Product (s): Tatou[®] 4S, Tatou[®] UTV 4S and Tatou[®] UTV Original

Subject

For track systems bought before November 1^{er}, 2010

Figure 1

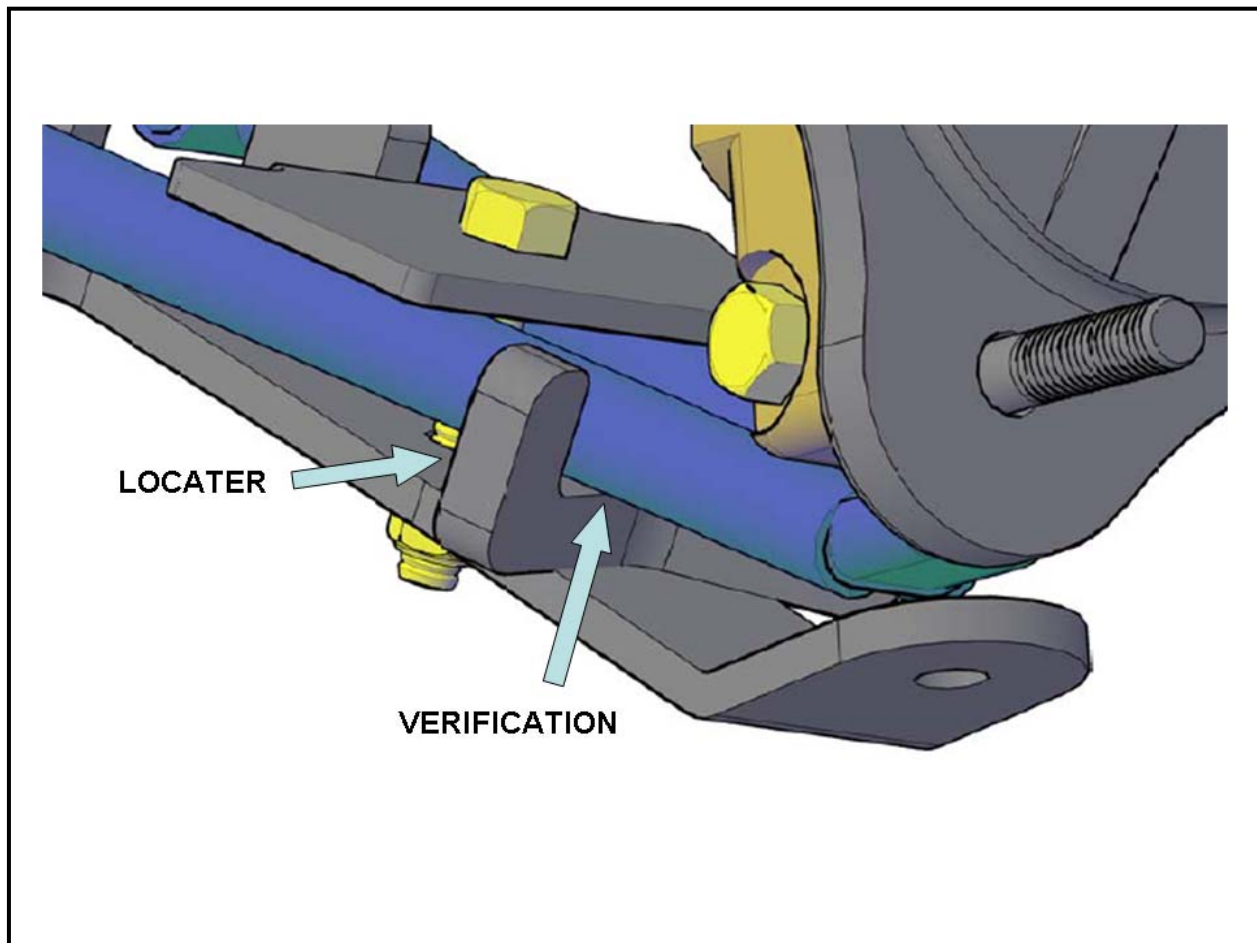
Remove the anchor brackets on the lower A-arms of the front suspension. Make a visual inspection at the tubes of the lower suspension a-arm toward the “U” part of the bracket which serves to locate the bracket on the A-arm. The a-arm tubes do not have marks of wear further contact with the anchor bracket. See Figures 1 and 2 for reference.

NOTE: Make this check correctly on each side of the vehicle, important breakings can arise following this contact.

After this verification, if you identify important wear spots on the tubes of the lower suspension A-arm, contact the customer service of Camoplast by e-mail: atvtracksystems@camoplast.com.
